**Subject: Request to Provide Remedial Cementing Plan  
PG&E Test Injection/Withdrawal Well 1  
Permit No. R9UIC-CA5-FY13-1  
King Island, San Joaquin County, California**

# **Salinity Analysis of the Upper Section in the PG&E Test Withdrawal- Injection Well 1**

RE: **PG&E King Island I/W well Cement Bond Log – Analysis and Opinion** - Specific Interval review

### Poorest appearing comparative section

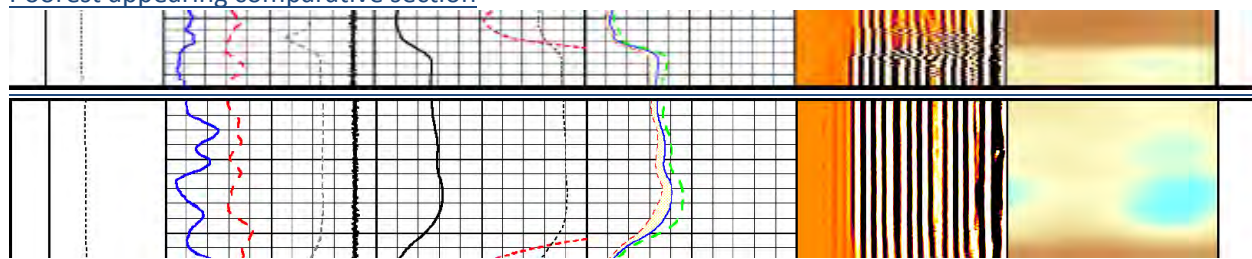
In looking throughout the logged interval, this section (950-984') would appear to have the poorest bond signature performance. Note that the amplitude curves are all moving, they are not in a straight line of equal amplitude, as you go from top to bottom. This in itself would indicate that this is categorically **NOT** free pipe. I collaborated with another expert in the logging field, Robert J. Lund, who partnered with me on the original analysis and with my own personal experience we believe this section to be at worst somewhat "bonded". The segmented bond tool pictures multiple sectors of the well, which is why there is an Amplitude max, min and average represented. Note also in this illustration in the 4th track that when the green and red lines separate this is an indication that there are differences between what is being read on the individual receivers. When they all track together the response is consistent at each of the receivers, indicating very similar materials in the sheath. "Free pipe" response is typically 50-51 mV. This level of response indicates the pipe is undamped by solid material behind the pipe. The Track 4 scale is 0mV on the left to 150mV on the right, as illustrated below..

985 – 1170'

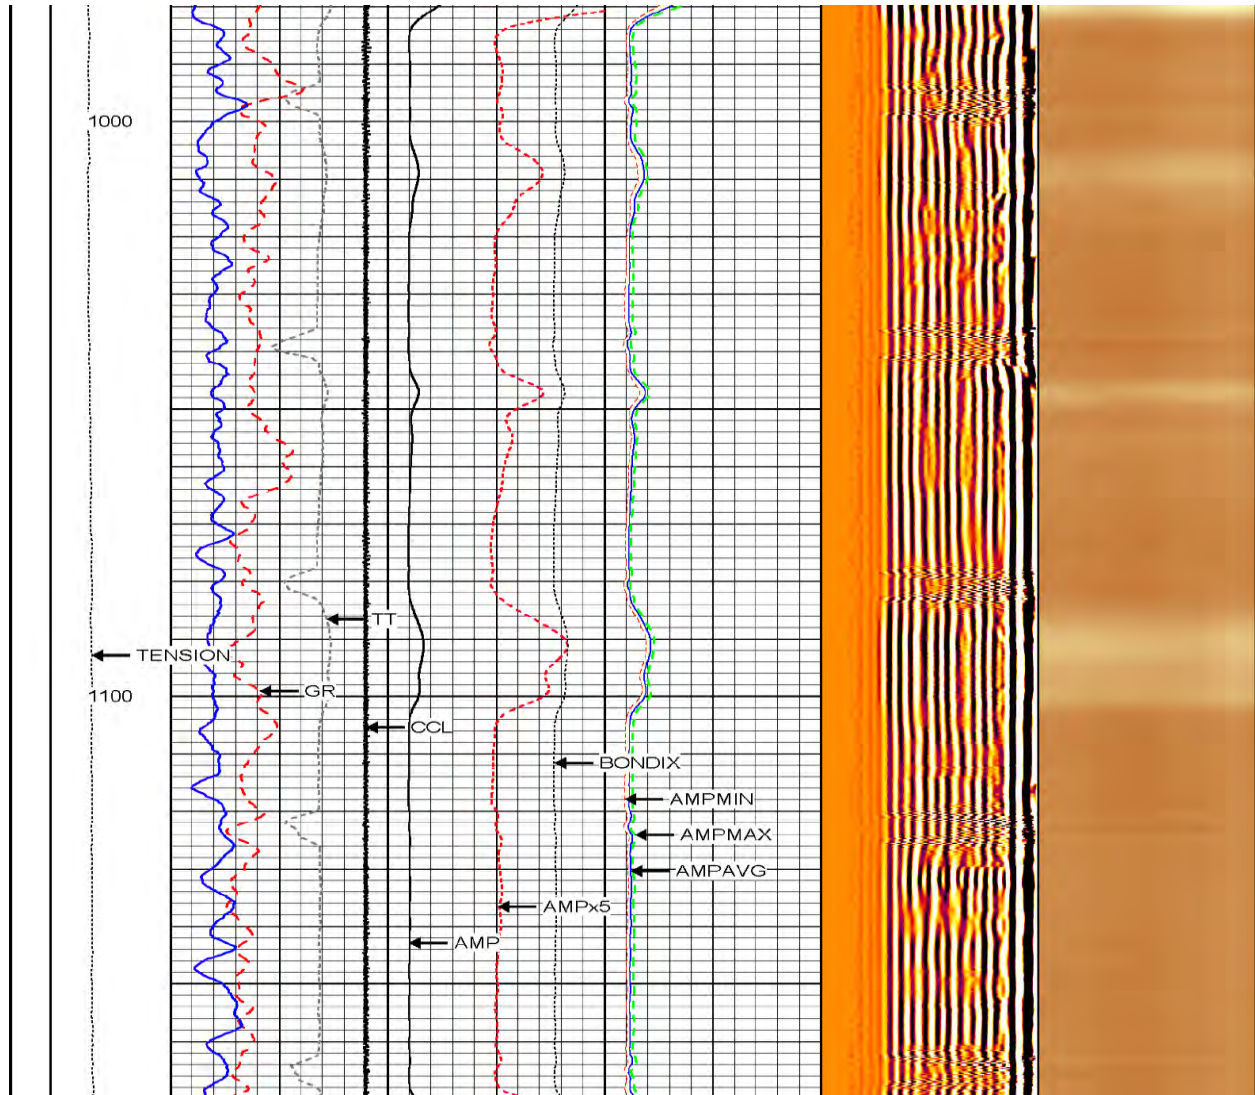
Analysis – Question 1 – Yes there is adequate isolation throughout the section. This section of the wellbore has some microannulus signature as noted by the early arrivals appearing in a “railroad track” configuration as well as the “chevron” appearance at the collar, which is an indicator of decoupling between the pipe and cement, but not between the cement and formation. Areas of consistent better “bond signature” in this section are from 1162-70’, 1134-42’, 1108-12’, 1050-64’, 1014-1030’, 985-1004’. By comparing the poorest in the wellbore section to this interval it is apparent there is much better bonding and much higher probability of an adequate hydraulic seal. We would recommend no remediation effort be conducted as the potential damage to the pipe (perforations) and the cement

sheath (potential shattering) and the adjacent formation (induced fractures) would potentially have a more deleterious outcome than the current wellbore conditions.

1370 – 1395'

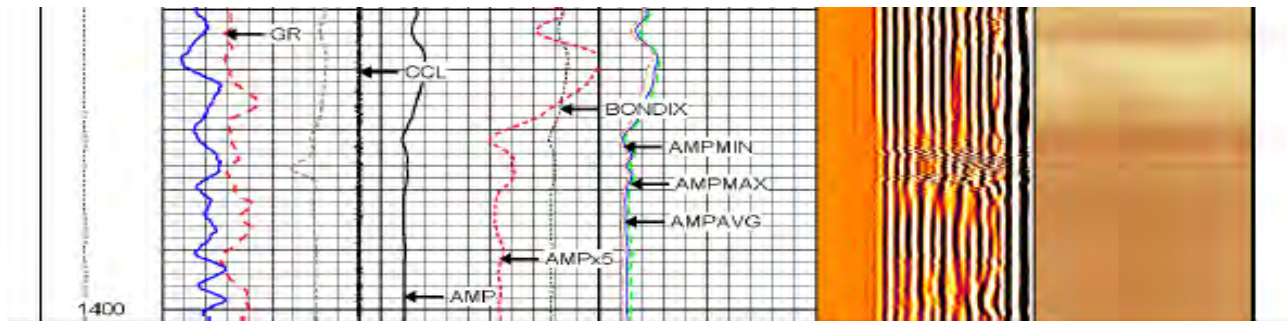
Analysis – Question 1 – There is adequate isolation from top to bottom of the interval. This sector of the well has very uniform response from a bond signal performance perspective. The amplitude curves are consistent across the interval. This section should need no remediation. There are moderately higher amplitudes directly above this section (1310-1370'), but immediately above and below the cement sheath looks to be well contained.

1618 – 1825'

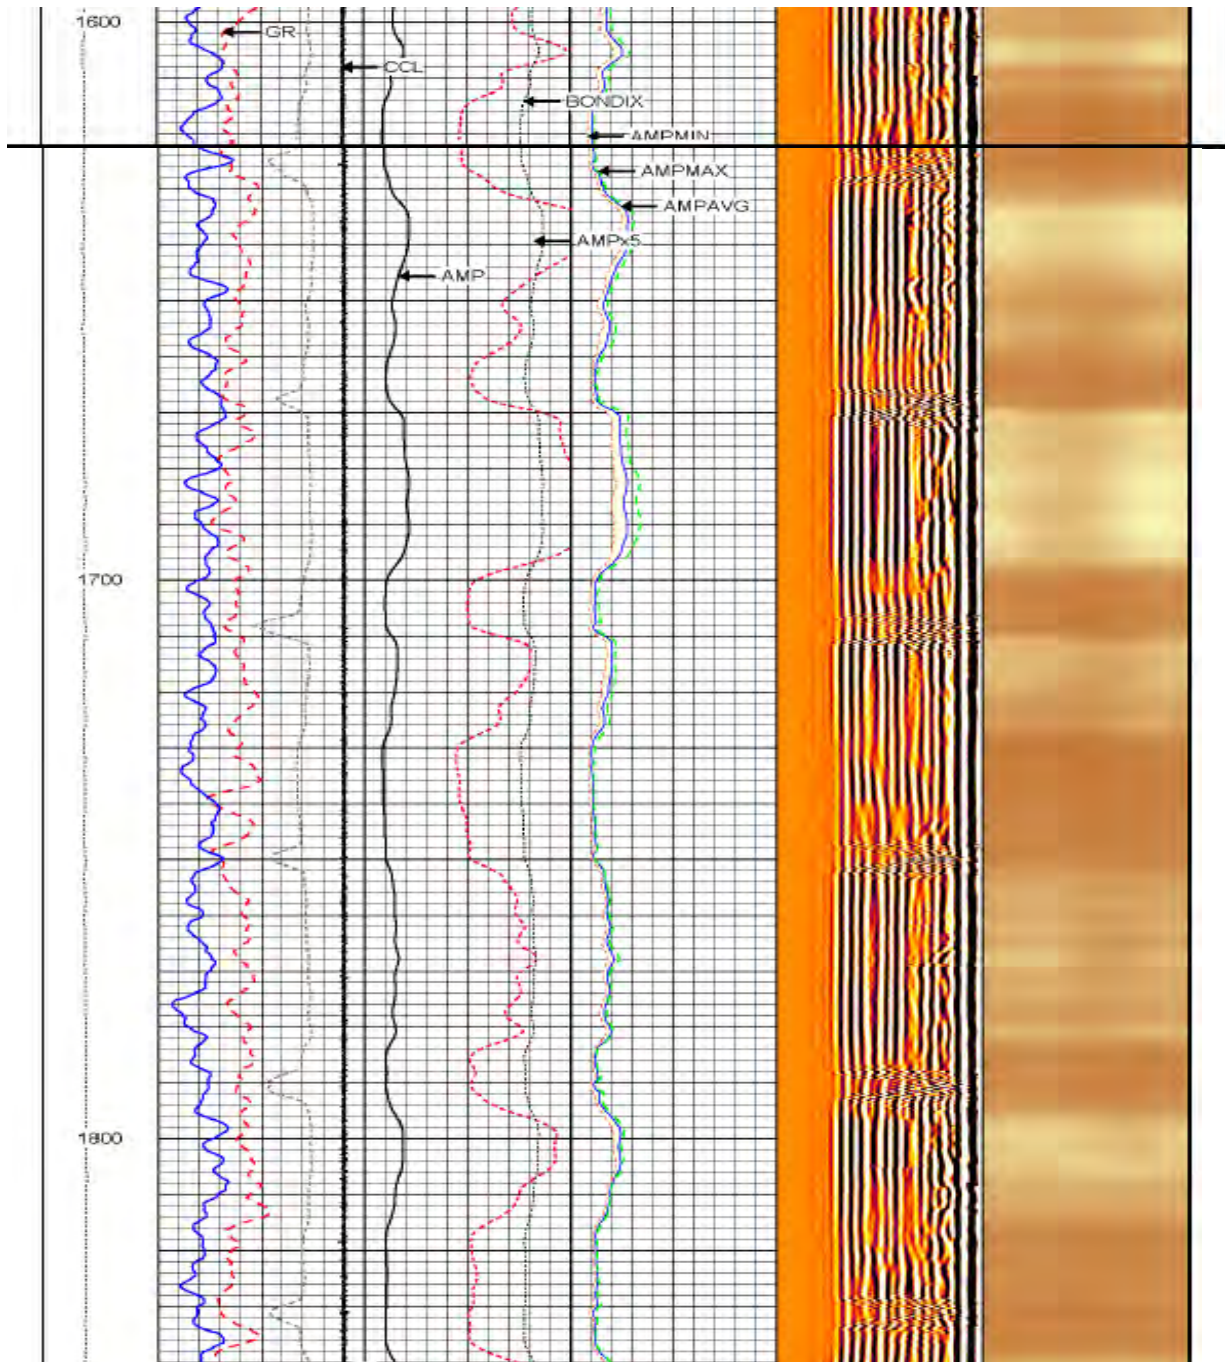
Analysis - Question 1 – Yes, there is adequate isolation from top to bottom of the interval, particularly 1618-30', 1660-68', 1700-10', 1730-50', 1784-93', 1816-36'. We recommend no remedial attempt in this section.

1935 – 2020'

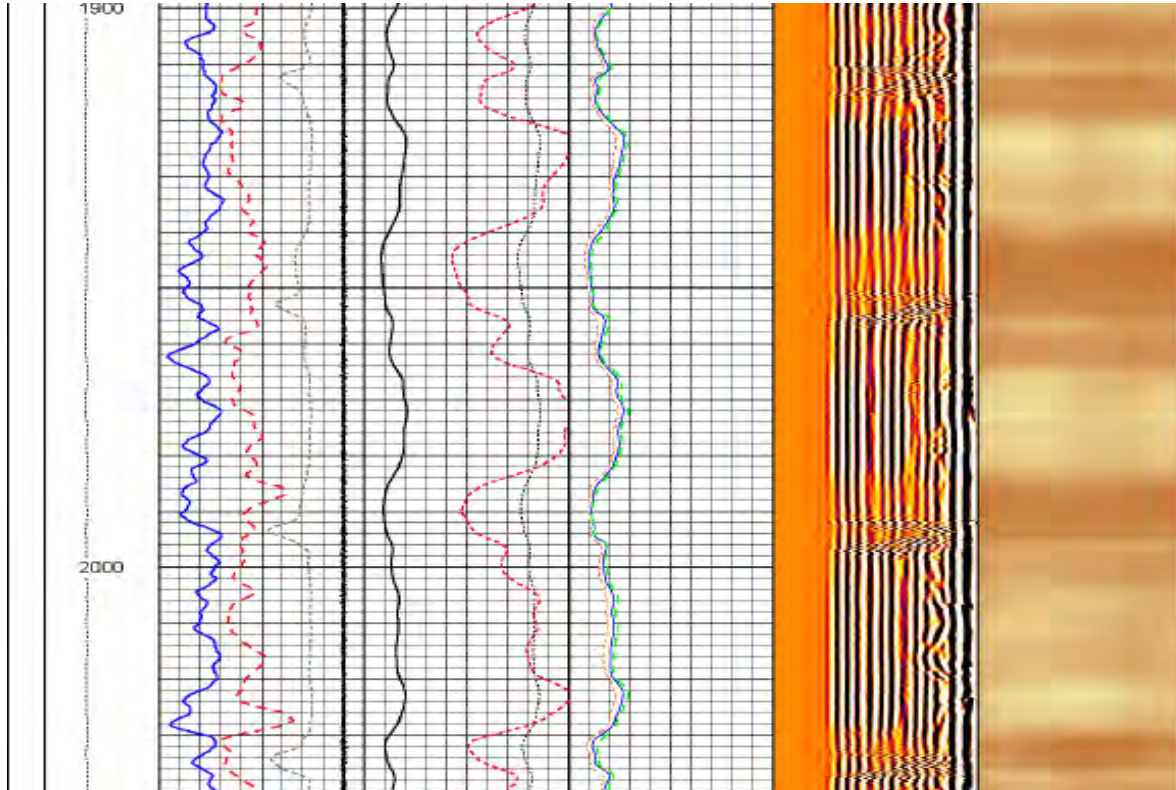
Analysis - Question 1 – Yes, there is adequate isolation from top to bottom of the interval, particularly 1942-54', 1986-94', 2030-34'. We recommend no remedial attempt in this section.

2650 – 2765'

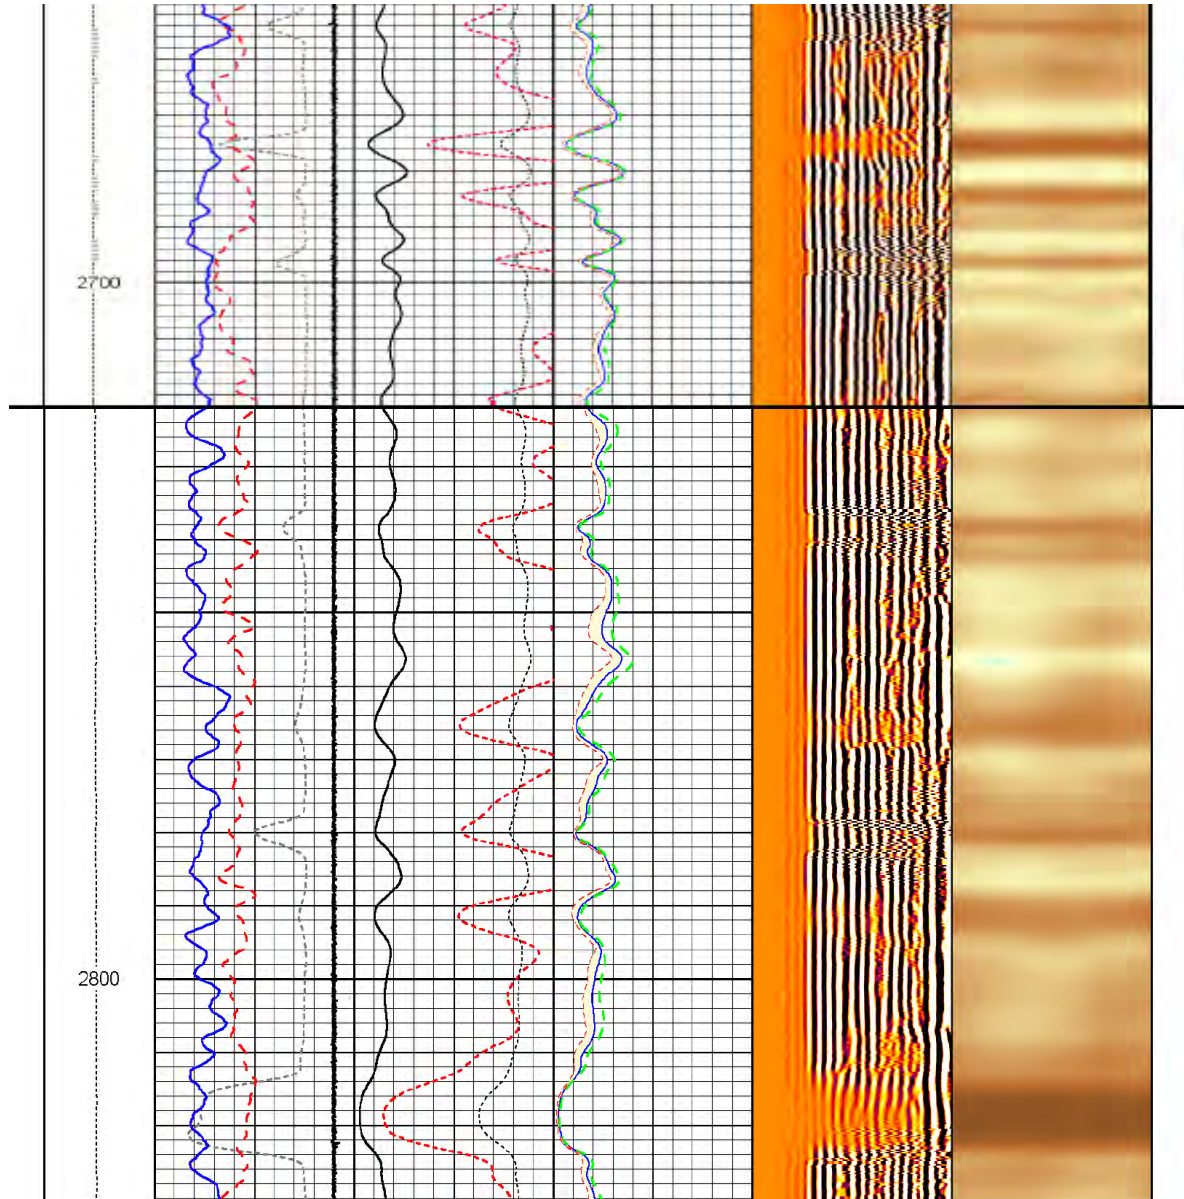
Analysis - Question 1 – Yes, there is adequate isolation from top to bottom of the interval, particularly 2674-76', 2683-85', 2764-66', 2814-24' would most certainly provide a barrier. We recommend no remedial attempt in this section.

3030 – 3085'

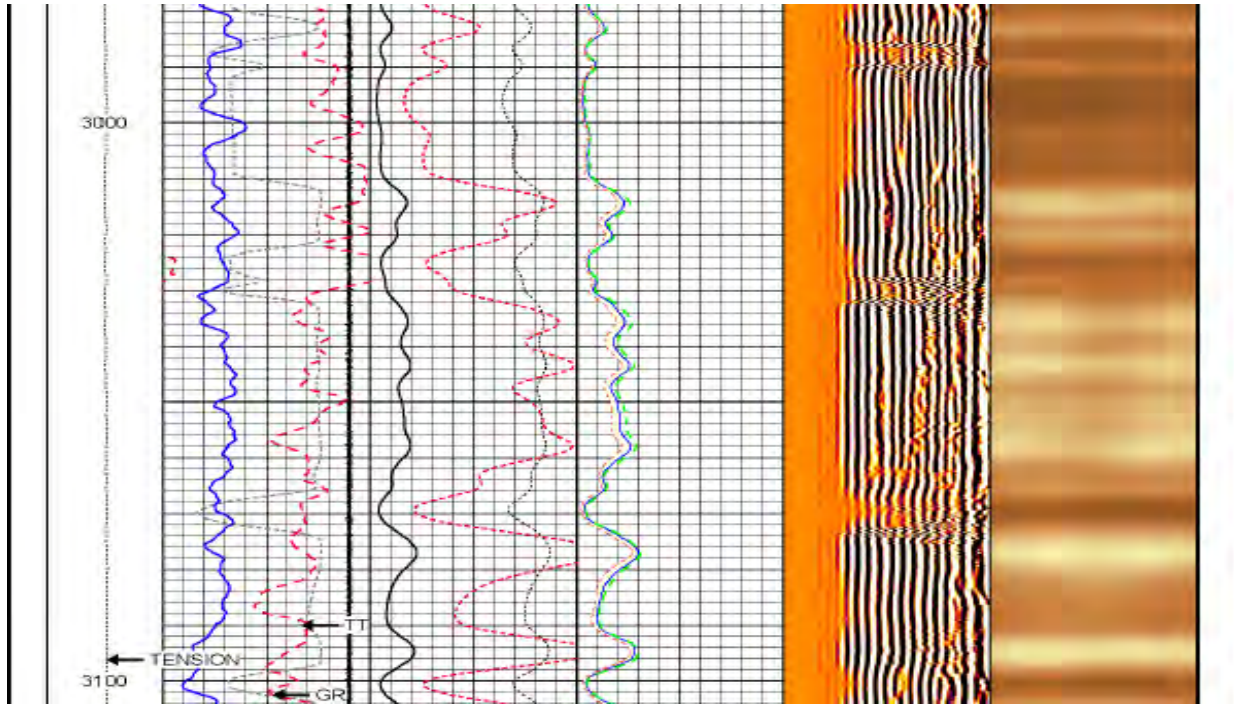
Analysis - Question 1 – Yes, there is adequate isolation from top to bottom of the interval, particularly 3022-32' would provide an upper boundary, 3063-73', 3083-91'. We recommend no remedial attempt in this section.

3195 – 3255'

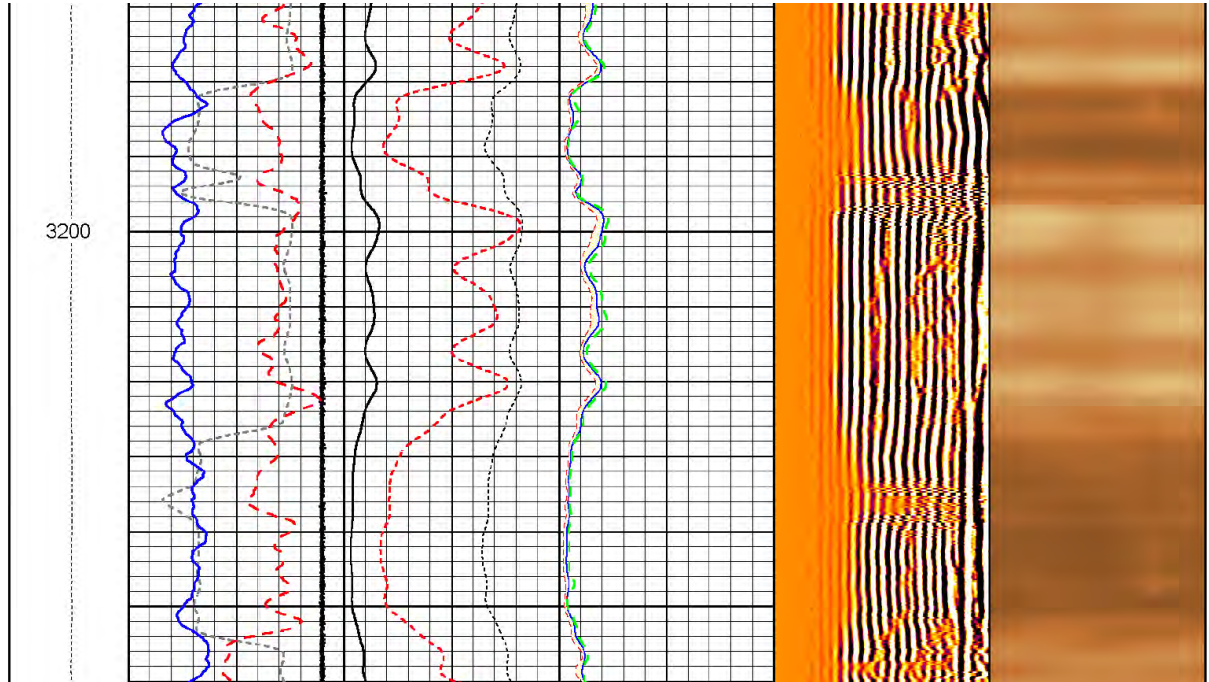
Analysis - Question 1 – Yes, there is adequate isolation from top to bottom of the interval, particularly 3180-96', 3204-06', 3215-17', 3222-60'. We recommend no remedial attempt in this section.

3265 – 3520'

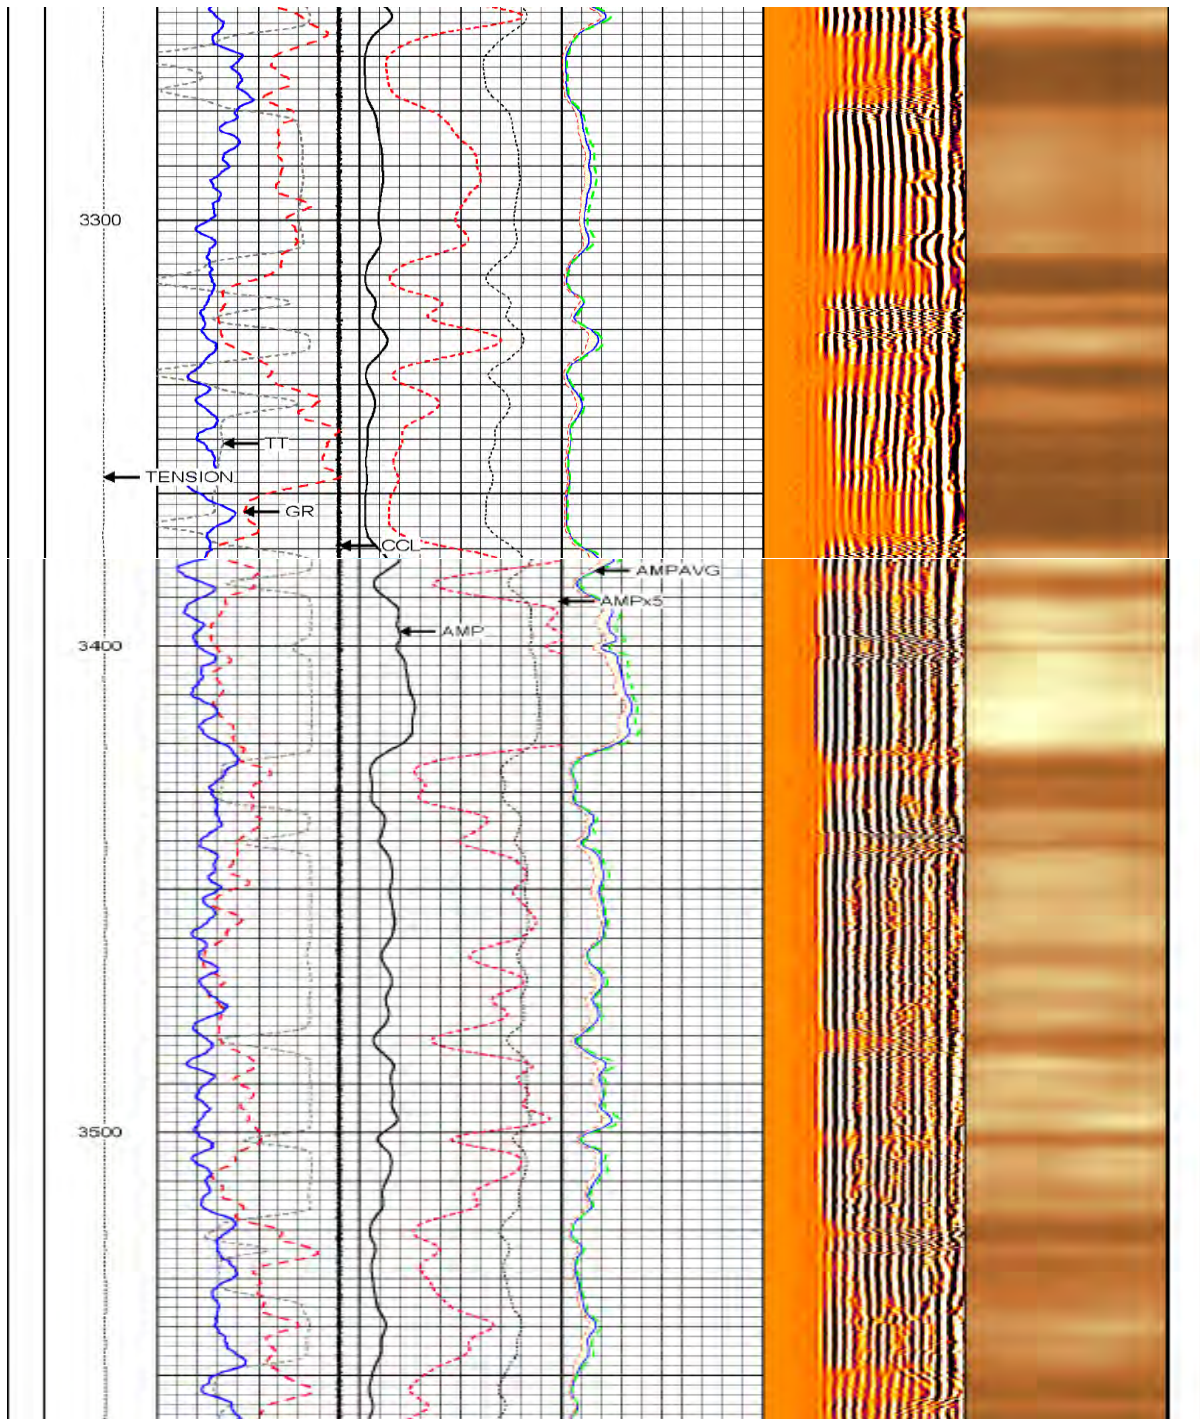
Analysis - Question 1 – Yes, there is adequate isolation from top to bottom of the interval, particularly 3265-3320', 3326-60', 3368-78', 3385-89', 3423-34', 3479-83', 3500-3', 3516-37'. We recommend no remedial attempt in this section.
